Re: Citrus County Central Landfill
Permit No. 21375-004-SC Phase 2 Landfill Construction
Progress Report #9

PERMIT . . : 21375-004-SC
Citrus County Central Landfill
Phase 2 Expansion

CITRUS COUNTY
PHASE 2 CELL EXPANSION

SHEET 5 OF 5
B. CLARK 1/14/03
JBM 1/14/03

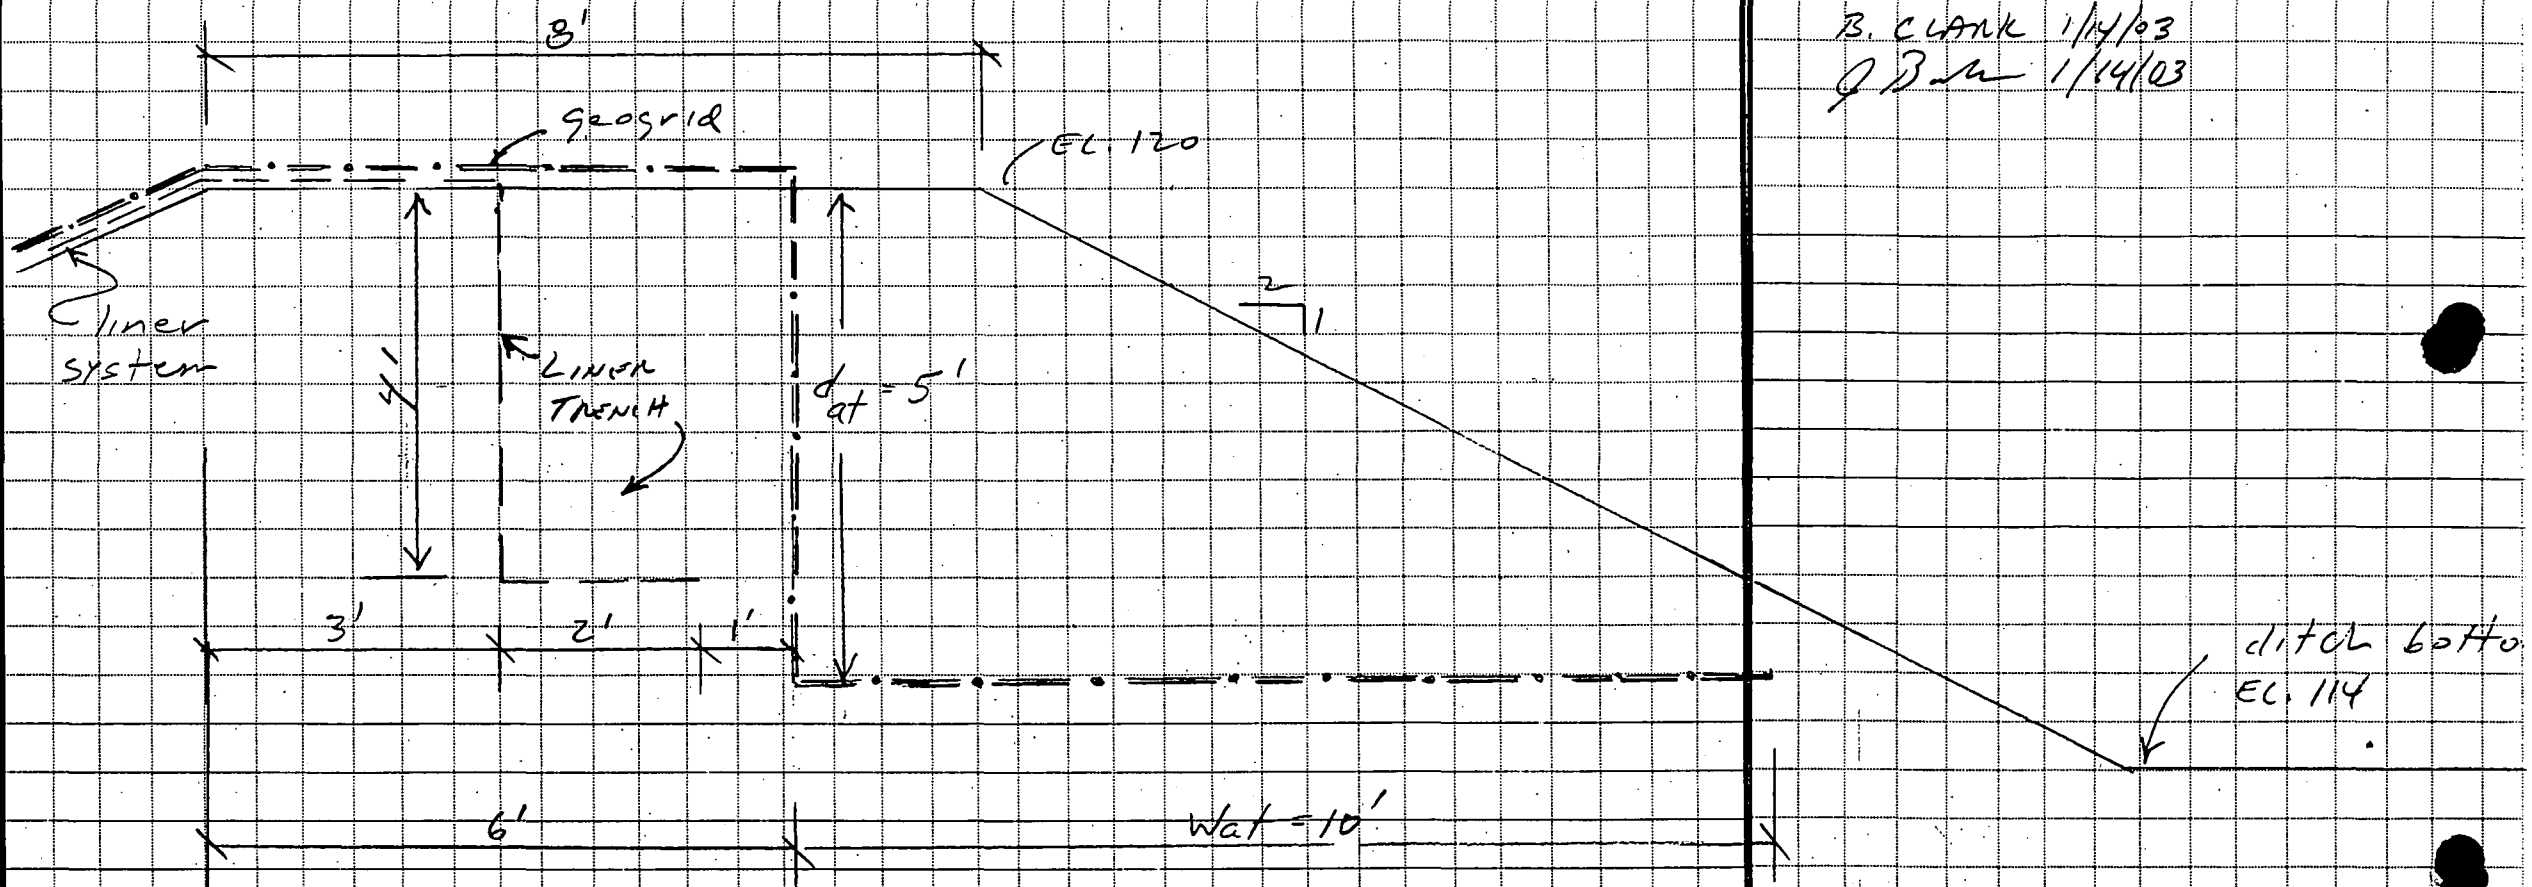
1. Project drawing Sheet 11
2. Technical specification Section 02930 Geocomposite
3. Calculations for the geogrid anchor trench on the south slope.

Geogrid is anchored in separate trench
(see sheet 5).

$$\begin{aligned}
 F_{TS} &= 2 \left[105 \left(0 + \frac{5}{2} \right) (1 - \sin 25^\circ) (\tan 25^\circ) (5) (0.8) \right] \\
 &= 2 \left[105 (2.5) (0.58) (0.47) (5) (0.8) \right] \\
 &= 2 \left[286 \right] \\
 &= \underline{572 \text{ lb/ft.}}
 \end{aligned}$$

$$\begin{aligned}
 F_{TB} &= 2 \left[105 (0 + 5) (10) (\tan 25^\circ) (0.8) \right] \\
 &= 2 \left[1,974 \right] \\
 &= \underline{3,948 \text{ lb/ft.}}
 \end{aligned}$$
